## Planning and Zoning Board

### *Staff Report*

**CASE NUMBER:** ZON18-00149  
**LOCATION/ADDRESS:** The 9800 through 9900 blocks of East Hampton Avenue (south side) and the 1400 Block of South Crismon Road (west side).  
**GENERAL VICINITY:** Located at the northwest corner of US-60 and Crismon Road.  
**REQUEST:** Rezone from PEP-PAD-CUP to PEP-PAD.  
**PURPOSE:** This request will allow for an office and commercial development.  
**COUNCIL DISTRICT:** District 6  
**OWNER:** Crismon Superstition Partners  
**APPLICANT:** Gilmore Planning and Landscape Architecture  
**STAFF PLANNER:** Lisa Davis, AICP Planner II

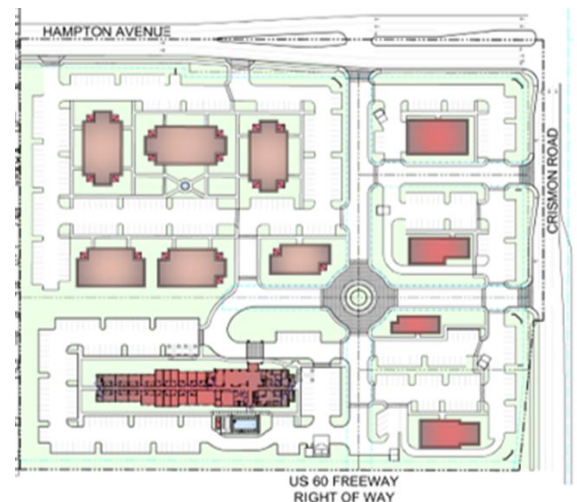
The PAD modifications and conceptual site plan indicate a building and landscape setback between the conceptual lots. These setbacks are inconsistent with the purpose of the PEP district to create an integrated campus setting and are not needed. Staff recommends eliminating the proposed interior side and rear yards between the conceptual lots (condition #8c).

The conceptual site plan does indicate that the proposed lots will not all have frontage on the public right of way. The MZO Section 11-30-6.H requires that every lot shall have frontage on a dedicated public street unless the lot is part of an approved PAD. As part of the PAD overlay the applicant is requesting lots that do not have frontage on the public right of way. Cross access and reciprocal parking easements will be required to be recorded as part of this development. Condition 7 outlines Staff supported PAD modifications.

- ii. **Removes interior and side yard setback standards that are not consistent with PEP requirements.**
  - b. **A revised conceptual site plan with the buildings moved closer to Hampton and no drives or parking between the buildings and the street and improved pedestrian connectivity between the various land uses.**

#### ***Pedestrian Areas (Z10-024 design guidelines page 11)***

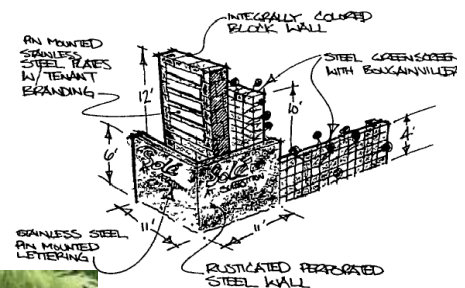
*Pedestrian circulation will be encouraged from one end of the property to the other along the central street as well as sidewalks along the public rights-of-way. End users of individual parcels should design their buildings to connect easily to these common areas to facilitate pedestrian connections and activity.*

*The primary pedestrian gathering area near the center of the property is planned to create a pleasant and inviting pedestrian environment. Users of parcels adjoining this area are expected to design their buildings to interact with this area for mutual benefit.*

*Where pedestrian pathways meet and cross vehicle pathways, decorative and / or textured pavements will be used. Barrier posts, bollards, screen walls, or large potted plants are to be used to provide safety to pedestrians from vehicular traffic.*

- a. **The incorporation of the site development standards for pedestrian areas (page 11) and architectural design standards (page 14) in the approved Superstition at Sole Design Guidelines (Z10-024).**
